Item ID: D350-607-541 Accept *N900040100* Setup Start *NS1*
 Revision ID: Stop *NS2*
 Item Name: Quick Release Heli-Utility-Basket™ Long, HD Lid, Spacepod™/Squirrel Cheek Comp.
 Start Date: 11/3/2015 Start Qty: 1.00 *1* Cust Item ID:
 Required Date: 11/13/2015 Req'd Qty: 1.00 *1* Customer:
 Reference:

DART SERVICE INSTRUCTION

TO AMEND INSTALLATION INSTRUCTIONS D350-607-3 Rev.D,
INSTALLATION INSTRUCTIONS D350-607-4 Rev. C AND
INSTRUCTIONS FOR CONTINUED AIRWORTHINESS ICA-D350-607 REV. 6
REF TCCA STC: SH94-14
REF FAA STC: SR00213NY
REF EASA STC: EASA.10016996
REF BRAZILIAN STC: 2007S03-03/-04/-05/-06

FIGURE 1: INSTALLATION OF D4775-041 FWD STRUT

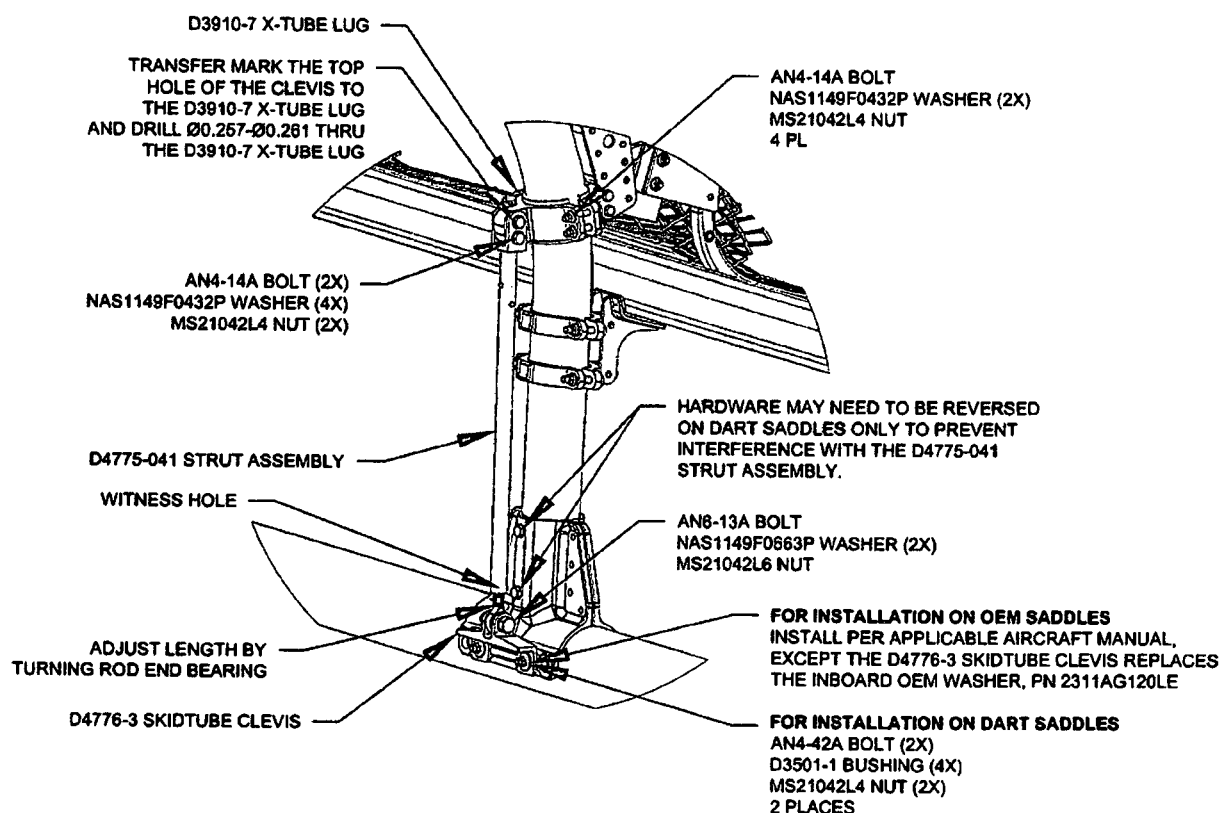
- 3.1 Substitute the Forward Lower D3910-5 X-Tube Lug with the D3910-7 X-Tube Lug as shown in Figure 1.
- 3.2 Install the forward D4775-041 Strut Assembly. Transfer mark from the upper hole on the clevis of the D4775-041 Strut Assembly to the D3910-7 X-tube Lug and drill thru the lug $\varnothing 0.257$ - $\varnothing 0.261$ as shown in Figure 1. Touch up chemical conversion coating per MIL-DTL-5541. Check the witness holes located at the bottom end of the D4775-041 Strut Assemblies to ensure that the thread from the rod end extends past the witness hole. **Torque MS21042L4/-4 nuts to 50-70 in-lbs (5.7-7.9 N-m). Torque MS21042L6/-6 nuts to 160-190 in-lbs (18.1-21.5 N-m).**
- 3.3 Complete the installation in accordance with Installation Instructions D350-607-3 Rev. D or D350-607-4 Rev. C.
